UNITED STATES PATENT AND TRADEMARK OFFICE

APPLICATION NO.	FILING DATE	FIRST NAMED INVENTOR	ATTORNEY DOCKET NO.	CONFIRMATION NO.
10/773,185	02/09/2004	Kia Silverbrook	MTB27US	8427
24011	7590	08/10/2006	EXAMINER	
SILVERBROOK RESEARCH PTY LTD 393 DARLING STREET BALMAIN, NSW 2041 AUSTRALIA				FIDLER, SHELBY LEE
			ART UNIT	PAPER NUMBER
			2861

DETAILED ACTION

Drawing A: Figure 27 from Silverbrook '457, edited for clarification

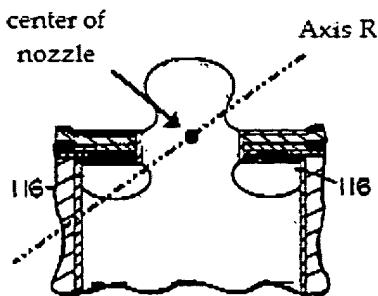
forming the gas bubble (*bubble 116*) on an axis (*axis R, see Drawing A below*) which extends through the center of the nozzle (*Drawing A*)

*regarding claims 2 and 20, the gas bubble (*bubble 116*) is formed on an axis (*axis R, see Drawing A below*) which extends through the center of the nozzle (*Drawing A*)
